DESIG	r	DRAWN BY	DART AEROSPACE LT HAWKESBURY, ONTARIO, CANADA	D
CHECK	KED M	APPROVED	DRAWING NO.	REV. A
	#	4	DSI 9203 sh	EET 1 OF 1
DATE	,		TITLE	SCALE
01.0	04.25	1	350/355 CARGO MIRROR	NTS
Α		01.04.25	NEW ISSUE

DART SERVICE INSTRUCTION

TO AMEND INSTALLATION DRAWING D350-561 REV. B CANADIAN STA: SH91-20 US FAA STC: SH856NE

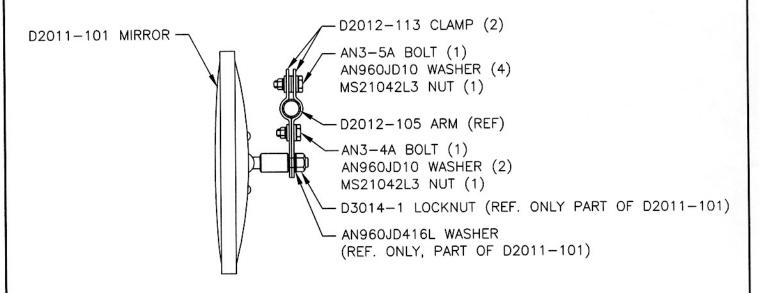
THE D350-561-045 MIRROR KIT SHOULD BE INSTALLED ON THE D2012-105 ARM AS SHOWN BELOW WHEN INSTALLING A D350-561-043 DUAL MIRROR ASSEMBLY.

THE PARTS LIST OF D350-561 REV. B SHOULD BE AMENDED AS FOLLOWS:

REMOVE:

QTY				
-045	-043	-041	Part Number	Description	
1			AN3-5A	BOLT	
2			AN960PD10	WASHER (OR AN960-10 OR AN960JD10)	
3		1	AN960PD416	WASHER (OR AN960-416 OR AN960JD416)	
1		1	MS21083N4	NUT (OR MS21042-4/L4)

ADD:

QTY				
-045	-043	-041	Part Number	Description
1			AN3-4A	BOLT
1		1	AN960JD416L	WASHER (REF)
1		1	D3014-1	LOCKNUT (REF)
